PROJECT
2915 W. ROBINSON ST.
LOT 1, CHICO SUB.
COLORADO SPRINGS

SHT. NO.
DEVELOPMENT PLAN
1 OF 1

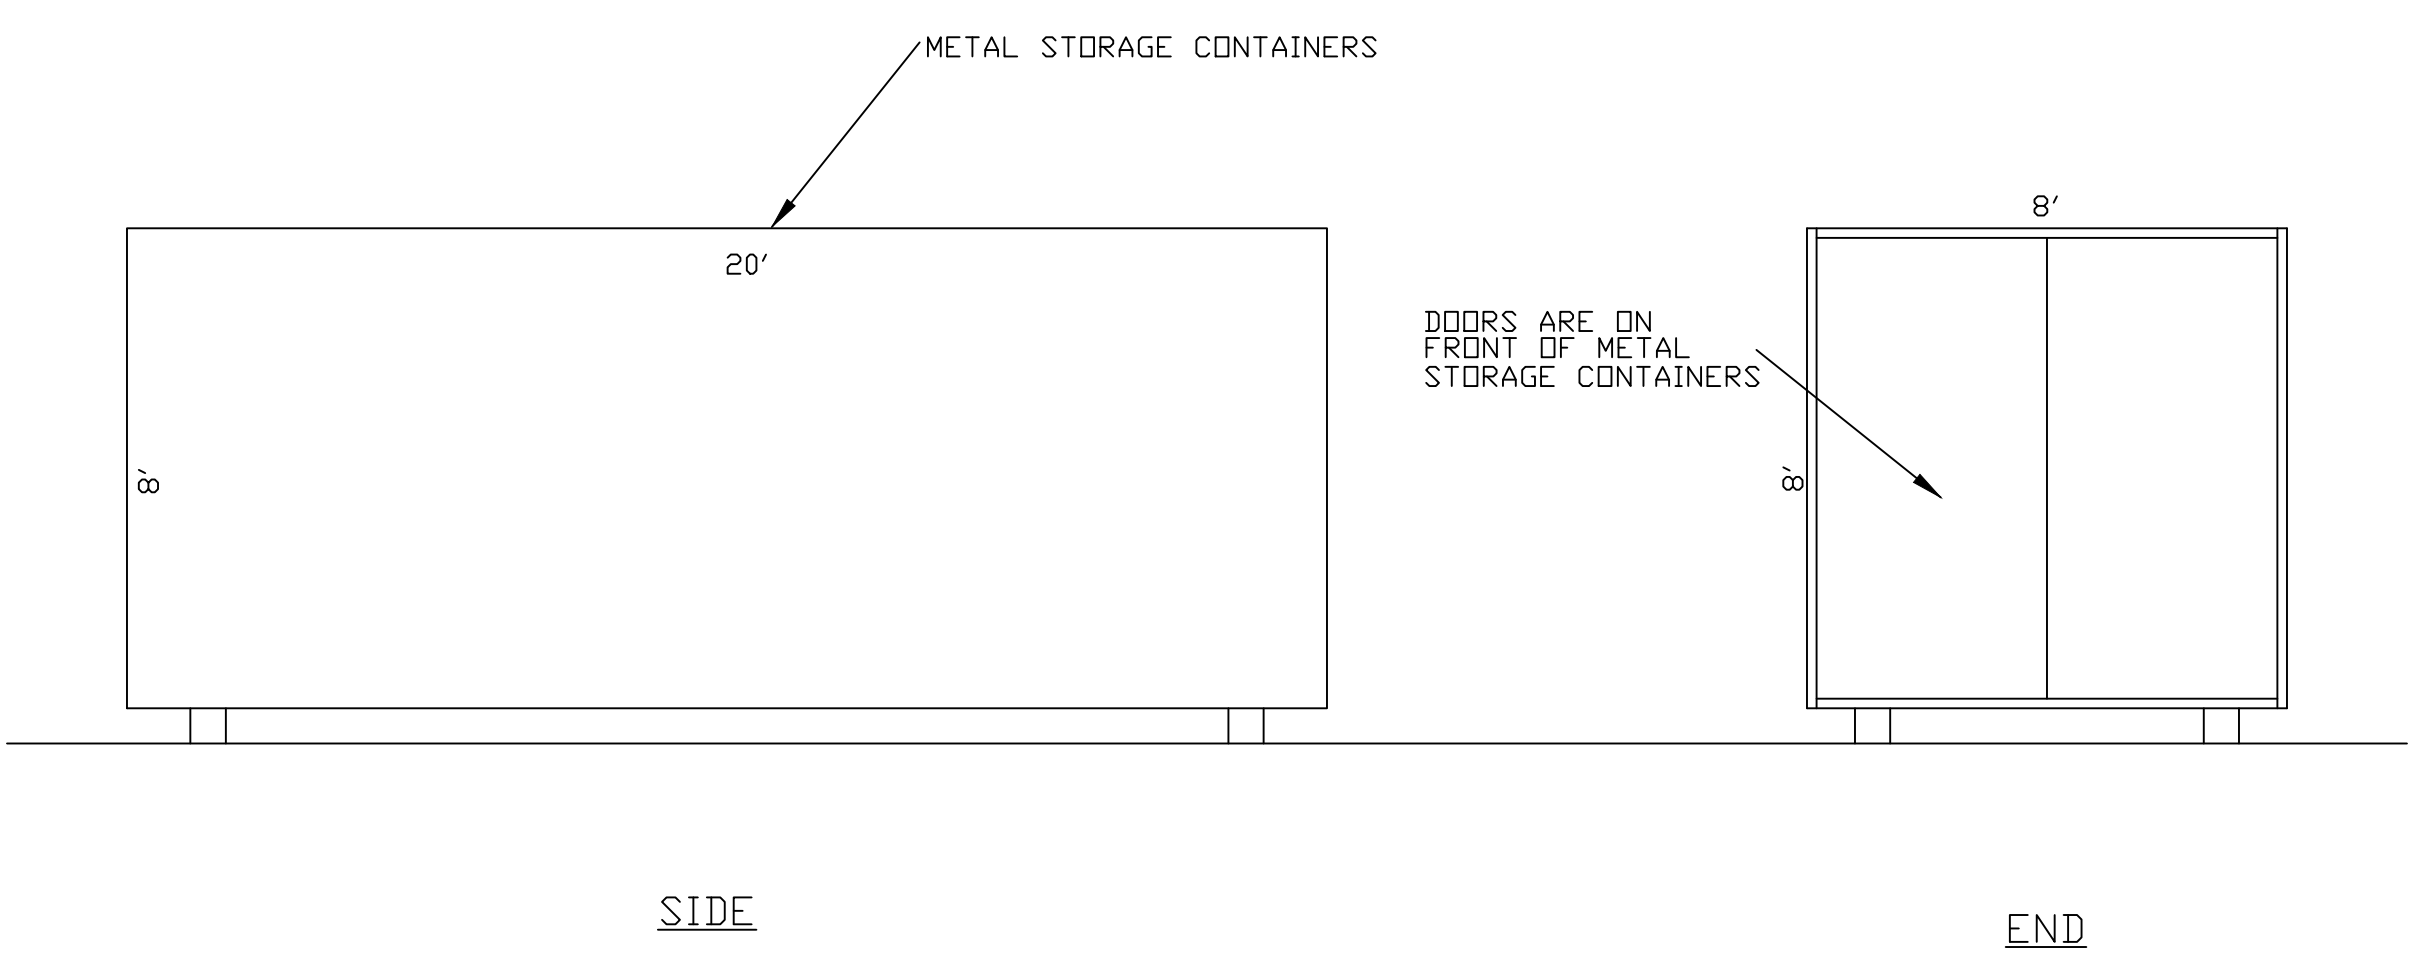
Label existing Wood Pole Single: CSU #OH045536

Show and label existing 50-foot public utility easement, Book 798 Page No. 453.

Show and label Secondary UG Conductor: CSU # 13FV-1
